1395 1–30 HP; 230VAC & 2–60 HP; 460VAC Power Board Replacement

Instructions

These instructions will provide you with the information necessary to correctly install a replacement Power Board in a Series B 1395 Drive. Replacement Power Boards now have revised Field Bridge connection points that must be carefully noted when installing the new model board.

Figure 1-1.
Field Bridge Connections -

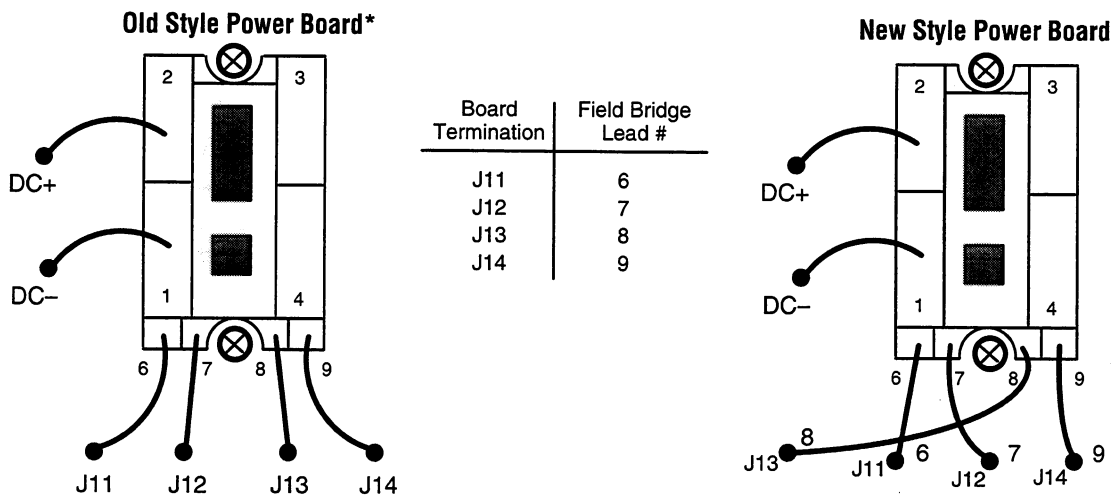
- Install the new Power Board in the drive.
- Install the leads that were removed previously from the Power Board,
IMPORTANT: Take special note of the new location of the J13 termination for Field Bridge lead #8 (Figure 1-1).
